Valley of the Winds Wind Farm (SSD-10641)

Response to request for information

April 2024

Project name **Valley of the Winds response to request for additional information**
Project no. **318001172-014**
Recipient **Department of Planning, Housing and Infrastructure**
Document type **Report**
Version **V1.0**
Date **5 April 2024**
Prepared by **Tawna Krause**
Checked by **Belinda Sinclair**
Approved by **Belinda Sinclair**
Description

Figure 2-1 | Overview of project refinements since Amendment Report

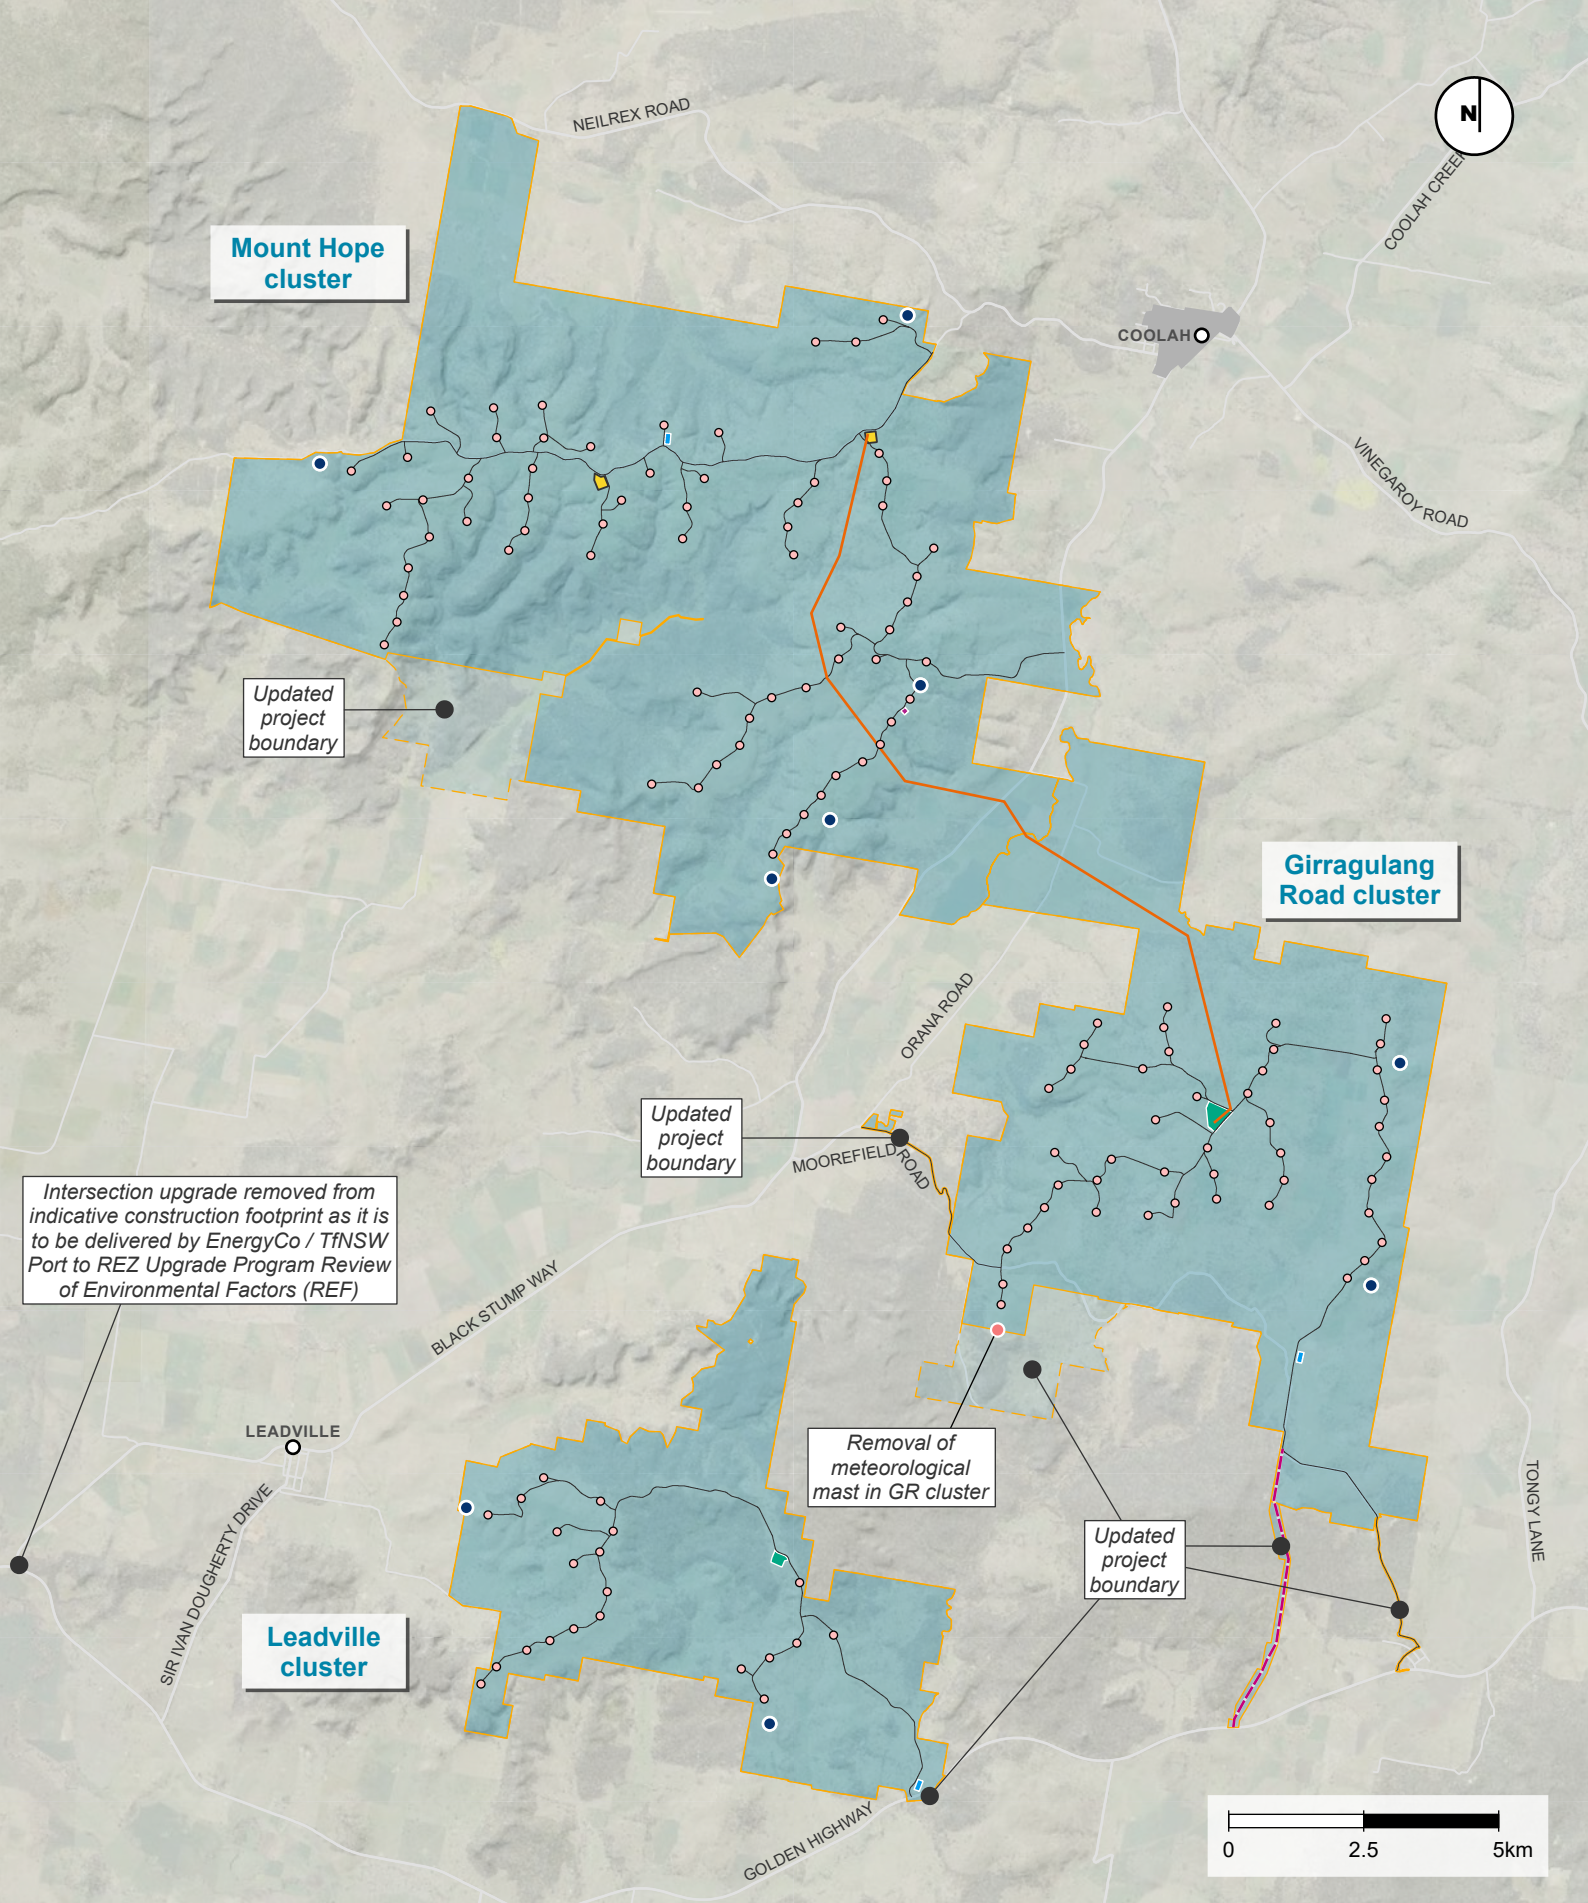
Following submission of the Amendment Report and in consultation with DPHI and landholders, minor changes were made to the wind farm site boundary to incorporate Project access roads and to exclude specific unutilised parcels of land. Changes to the wind farm site boundary are presented in **Figure 2-1**.
